Access Compliance Report

Public Rights-of-Way

(Curb Ramps)

Intersection ID: 46306	Main Street: BECKET RIDGE RD	Cross Street: AUGUSTINE_WY	Location: NE
ADA ID: BEE76D8CE883	Ramp Type: Perp	Initial Pass/Fail: Fail	Overall Compliance: No
		Severity Score: 8.75

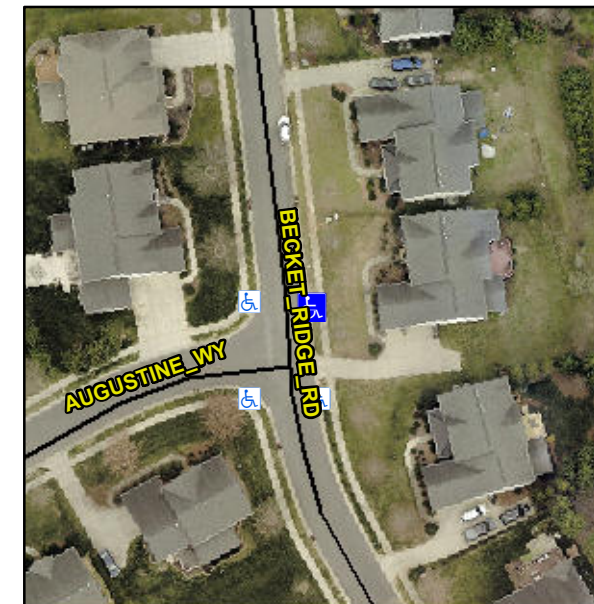
Not Found, R304.5.1

Compliance	Description	Data	Compliance	Description	Data
N/A	Ramp Length (in)	46.0	Yes	Ramp Slope (%)	6.5
No	Ramp Width (in)	47.5	Yes	Ramp XSlope (%)	1.0
N/A	Flare Type LT	N/A	N/A	Flare Type RT	N/A
N/A	Flare Slope LT (%)	N/A	N/A	Flare Slope RT (%)	N/A
N/A	Flare Traversable LT?	N/A	N/A	Flare Traversable RT?	N/A
N/A	Landing Length (in)	N/A	N/A	DWS Provided?	N/A
N/A	Landing Width (in)	N/A	N/A	DWS Contrast?	N/A
N/A	Landing Slope (%)	N/A	N/A	DWS Length (in)	N/A
N/A	Landing X Slope (%)	N/A	N/A	DWS Full Width?	N/A
N/A	Landing Curb? (Y/N)	N/A	N/A	DWS Offset (in)	N/A
N/A	Shared Landing?	N/A			
N/A	Gutter Ponding?	Yes	N/A	Gutter Slope (%)	N/A
N/A	Gutter Lip Ht (in)	N/A	N/A	Gutter X Slope (%)	N/A
N/A	Painted X Walk1?	No	N/A	Painted X Walk2?	N/A
	X Walk 1 Direction	To W		X Walk 2 Direction	N/A
N/A	X Walk 1 Width (in)	N/A	N/A	X Walk 2 Width (in)	N/A
	X Walk 1 Slope (%)	1.3		X Walk 2 Slope (%)	N/A
	X Walk 1 X Slope (%)	1.4		X Walk 2 X Slope (%)	N/A

Remove & Replace Entire Ramp.
